Amendment 001

Re: Amendment #001
Renovate Restrooms for Handicap Accessibility
VA Project #636A8-12-007

RENOVATE RESTROOMS FOR
 HANDICAP ACCESSIBILITY
 AMENDMENT #1

WOMENT'S 3E11A REVISED ADA STALL

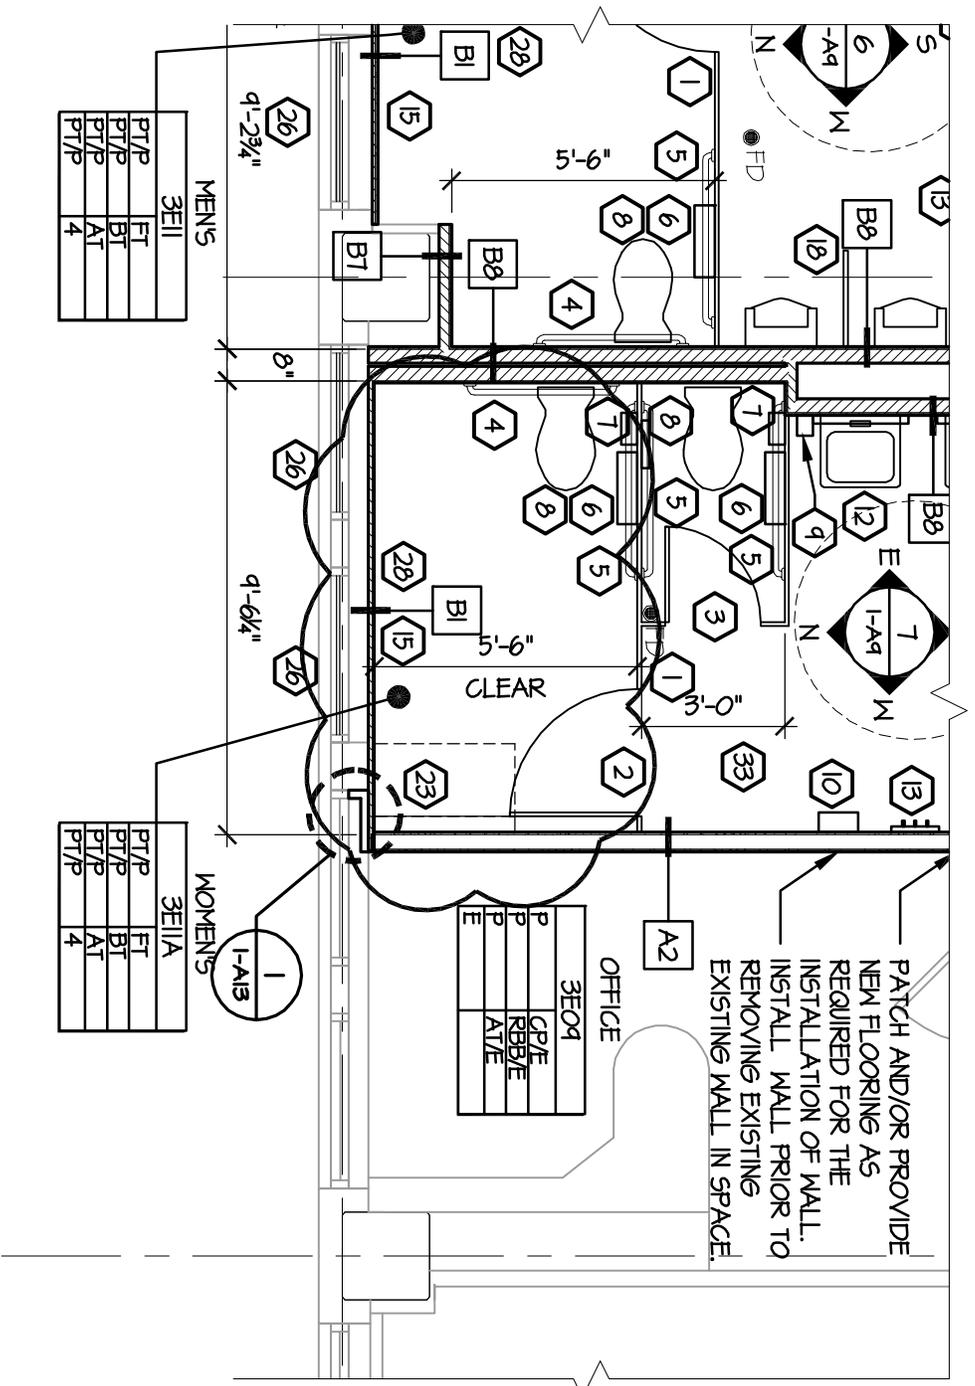
- D) Append the text " - ALTERNATE 2" to the end of Detail #2's title.
- E) Refer to detail 3 – 3rd Floor Construction Plan and flip the ADA stall so the toilet and accessories are located on the southeast corner in lieu of northeast corner of the stall. Refer to ES-1 for more information.

REVISED 10TH FL CORRIDOR PAINT LIMITS

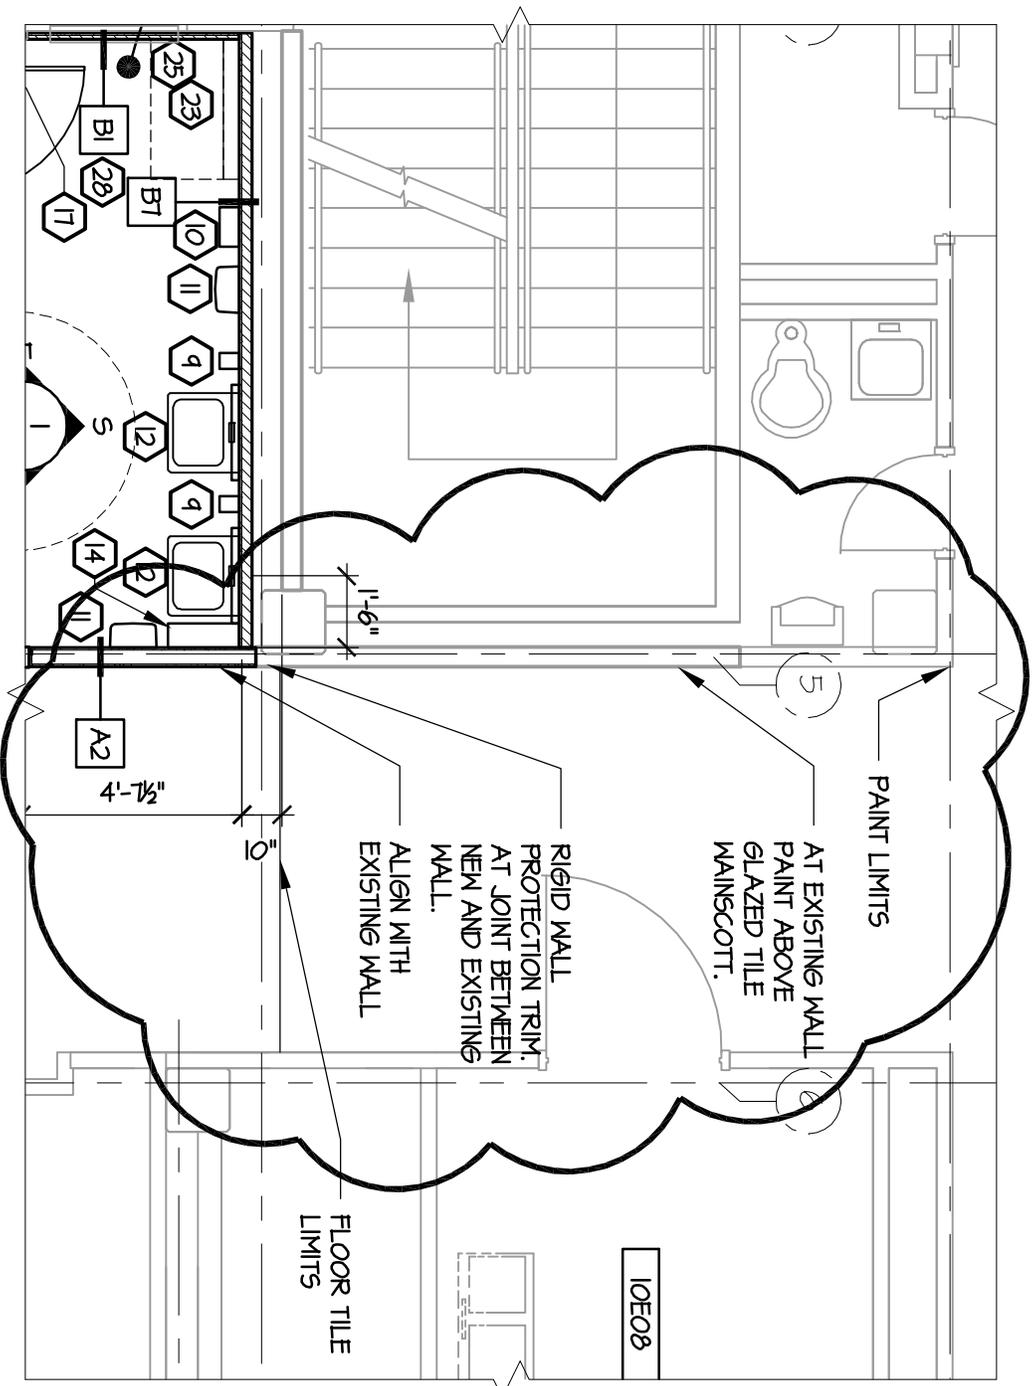
- F) Refer to detail 4 – 10th Floor Construction Plan; along grid line 5M where the new gypsum wall aligns with existing wall provide ridged wall protective trim at joint (similar to InPro small decorative trim). New gypsum wall to be painted from finished floor to ceiling, existing wall to be painted above wainscot glazed tile to ceiling. Refer to ES-2 for more information.

PS-1

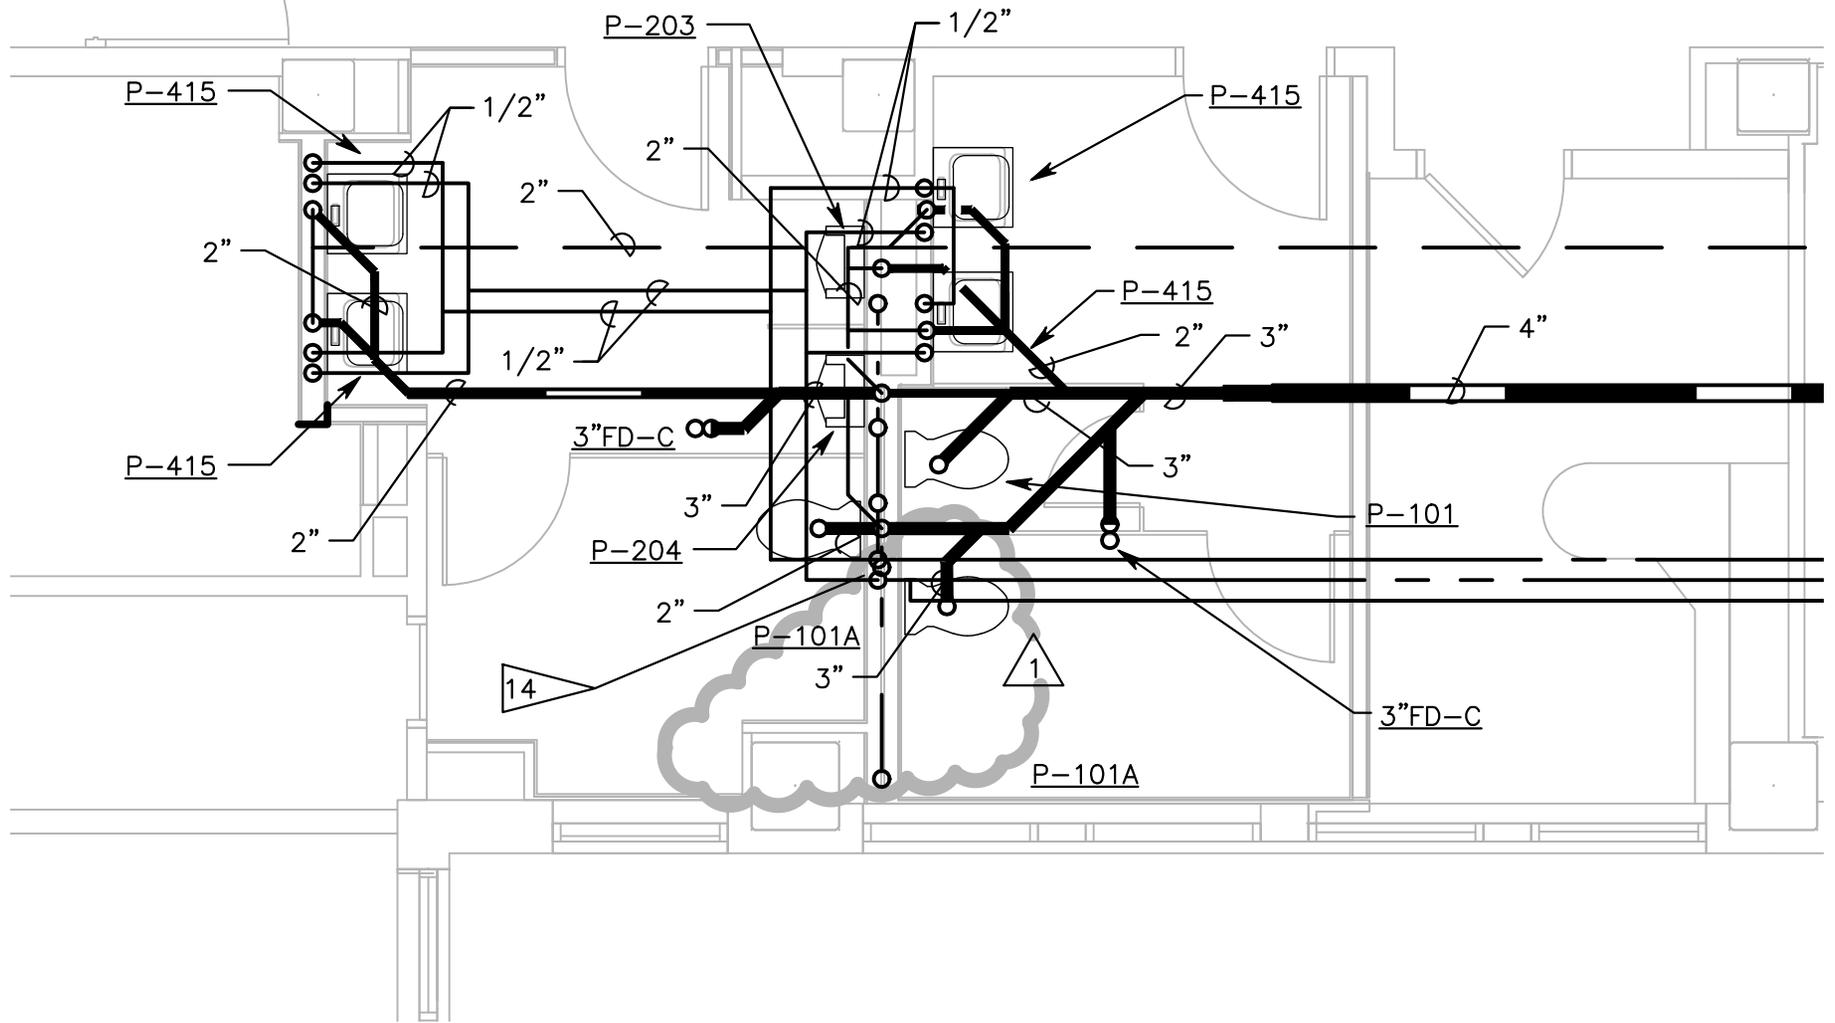
- A) Append the text " - ALTERNATE 2" to the end of Detail #2's title.
- B) Append the text " - ALTERNATE 3" to the end of Detail #3's title.
- C) Modify detail 4 as shown in attached Sketch PS-1 to move the toilet to the other side of the stall in the north stall.
